**D5 / SECTION F      RESPONSE TO ISH4 [REP4-084] AND [APP-058]: SUBSTITUTION OF UNABATED CCGT.....34**

**D5 / SECTION G      RESPONSE TO ISH4: CLIMATE BENEFITS OF CQLCP.....52**

**D5 / SECTION H      SUMMARY / INVENTORY OF KEY SUBMISSIONS / REQUESTS MADE BY CESL.....55**

**Figure 1: Exergia report Figure 3-30 reproduced**

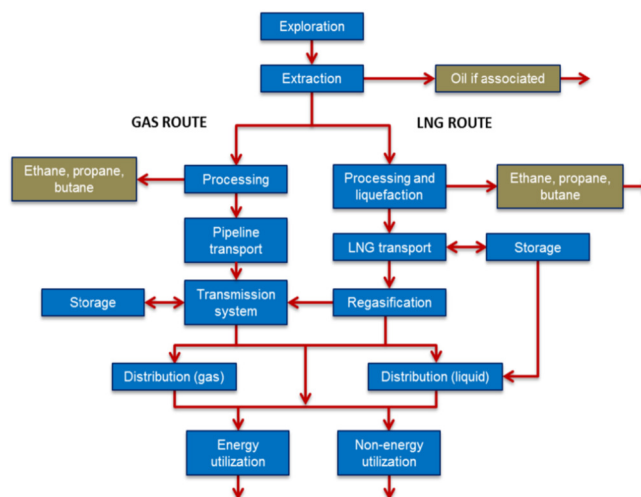
- 16 The emissions released to the atmosphere along each stage of a stream may be summed along the different stages depending upon the source and type of transport (pipeline or LNG). This is illustrated below from Exergia Figure 3-30.

Figure 2: Exergia report Figure 3-33 reproduced

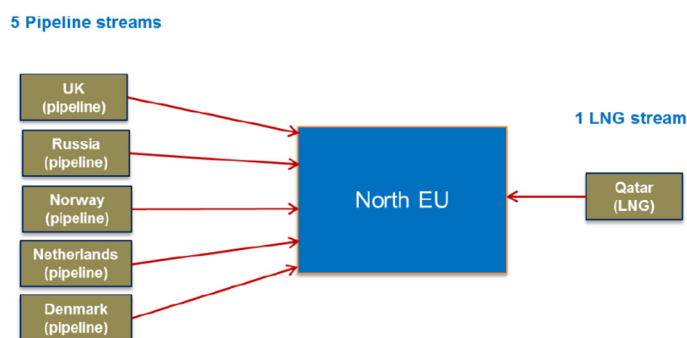
17 In 2015, Exergia identified these natural gas streams arriving into the North EU area, as shown by Figure 3-33 from the report. The EIR says “Data from the upstream and mid-stream stages for gas supplied from UK, Norway, Netherlands and Qatar liquefied natural gas (LNG) are taken from Table 5-23 Carbon Intensity of Natural Gas streams arriving to North EU” which makes it clear that the UK has used these gas streams for its modelling its emissions factors since Exergia was adopted in 2017 (DUKES year 2015). This assumption of UK gas stream sources may have been adequate in 2015, but as above it is quite clearly inadequate in 2025/2026 and for 2035-2065.

**Figure 3: Clean Flexibility Roadmap (2025) Figure 1 reproduced**

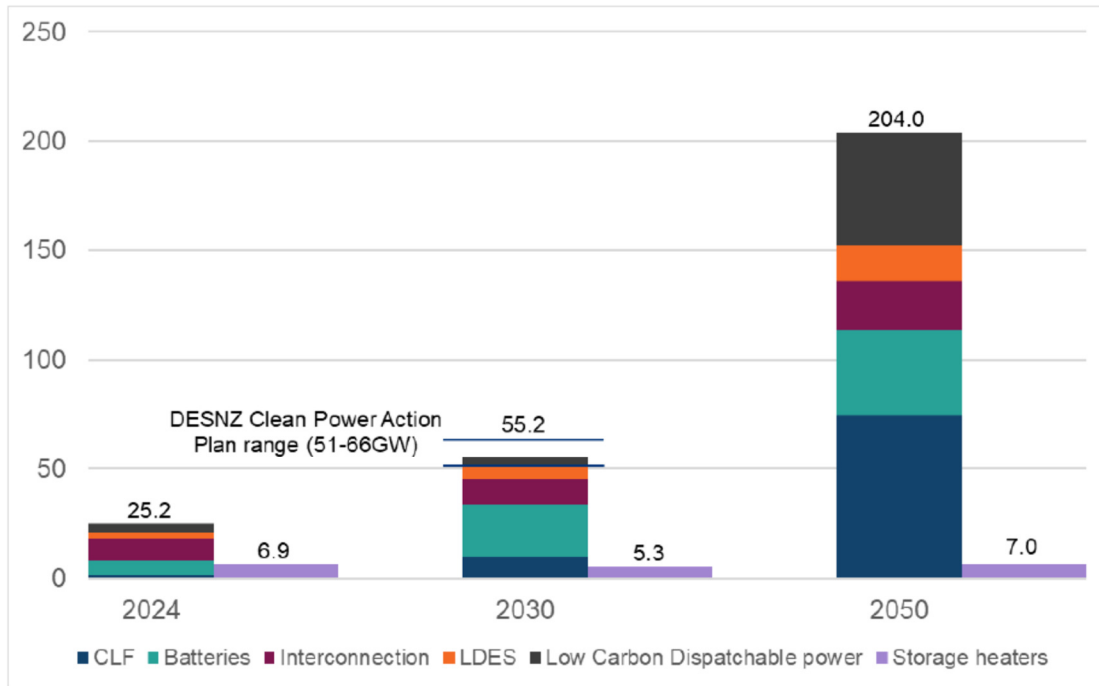
167 Together these can provide total system needs of tens of gigawatts of dispatchable and long-duration flexible capacity. These technologies are treated as complementary, with different operational roles depending on system conditions, duration of scarcity events, and energy availability. This has been described in the Government’s “Clean Flexibility Roadmap” (2025) supplied as a stand-alone appendix to the examination library: Figure 1 from this document is reproduced below.

- (B) Whilst acknowledging that the Government currently proposes implementing Power CCS (including gas fired CCS) as dispatchable power to 2050 (Figure 3 in this submission shows the Government projections in the Clean Flexibility Roadmap (2025)), CESL posits that reducing costs in other flexible technologies such as energy storage and in renewables has the potential for less Power CCS to be required, and more other flexible technologies to be implemented to 2050. The key climate argument which pertains here is that for every MW of flexible supply delivered by other means than with Power CCS, the upstream emissions and short-term climate heating penalty of Power CCS is avoided. CESL posits that investment in Power CCS may prevent investing in other flexible technologies, faster and at greater scale.

Figure 4: Comparison chart of Carbon Intensity of unabated vs abated with sensitivity testing

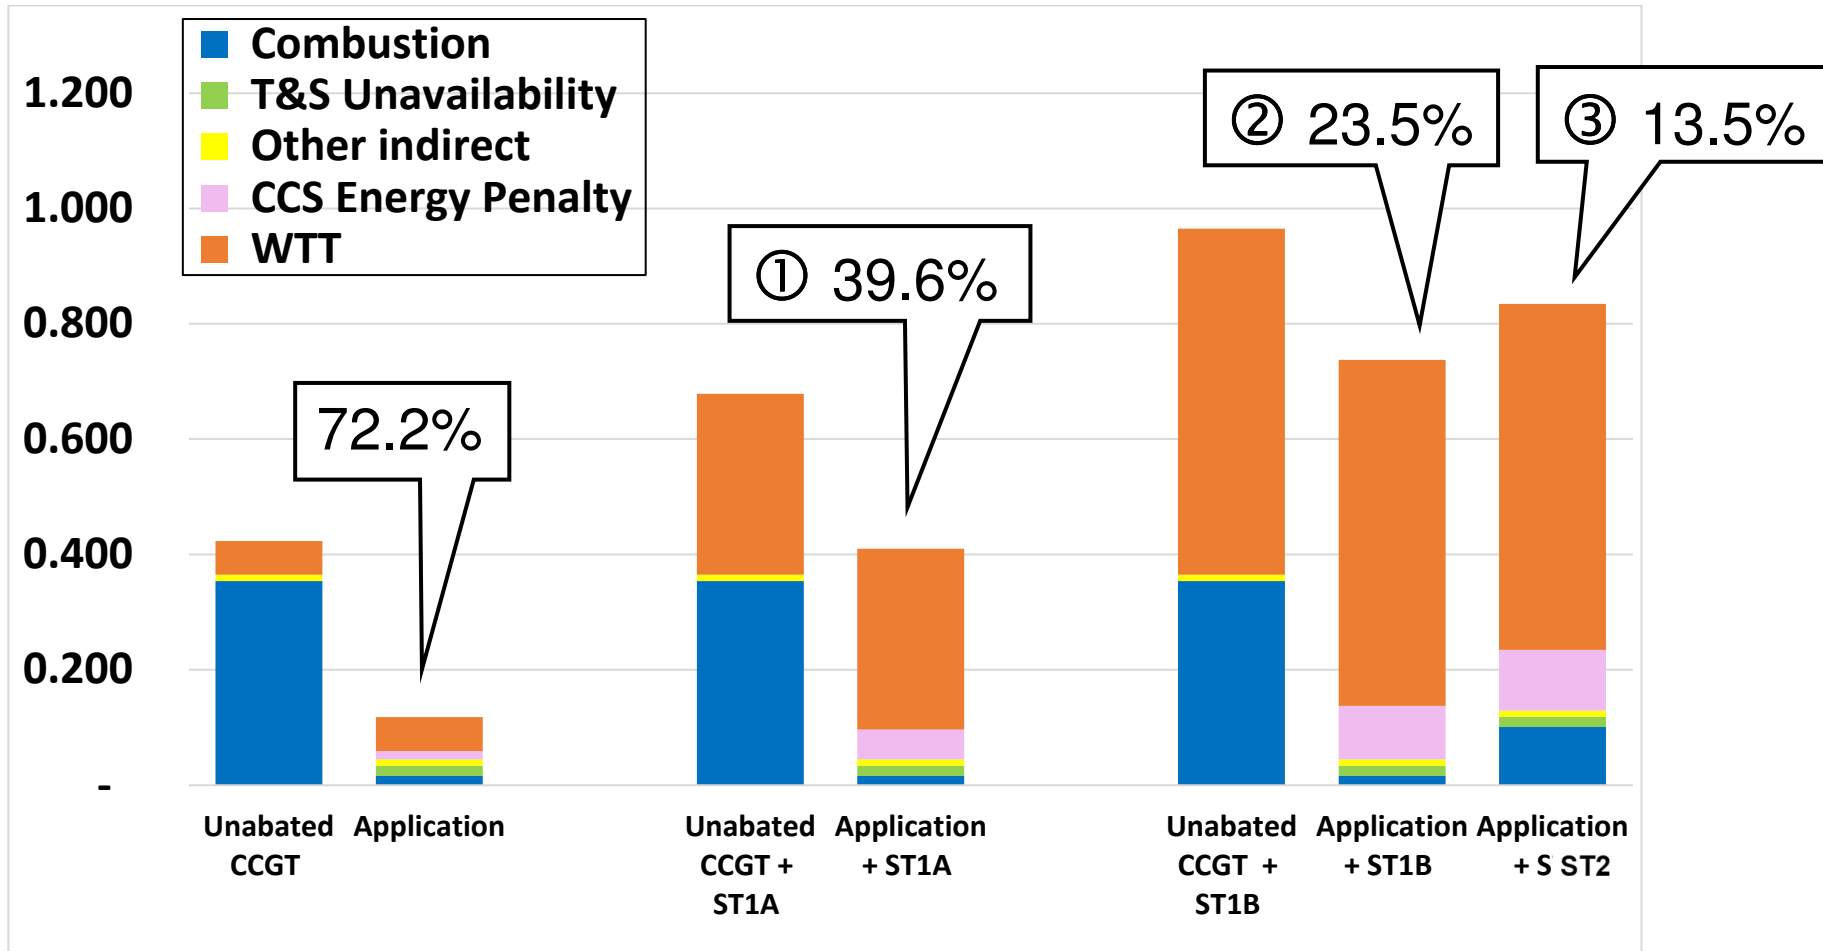
202 The left hand comparison in Figure 4 above is the comparator to the data shown in Plate 20-2 [APP-058] (without the UK Grid Average). This shows on the slightly different assumptions in CESL's calculation method (e.g. that uses an unabated CQLCP as the comparison unabated plant), but with the default assumptions in the ES (ie DESNZ WTT factor at 95% capture) that the saving with the abated CQLCP is 72.2% (this is actually slightly better than the applicant's 71.4%).

203 When the indicative sensitivity test data for long-term CO2 effects only (ST1A) from [REP3-085], Table 5 is applied, the saving drops to 39.6% (① on Figure 4).

204 When the indicative sensitivity test data for short-term methane climate impacts are included (ST1B) from [REP3-085], Table 5, the saving drops to 23.5% (② on Figure 4).

205 When the indicative sensitivity test data for carbon capture rate (ST2) from [REP1-077], Table 2 is applied cumulatively (ie: on top of ST1B), the saving drops to 13.5% on (③ Figure 4).
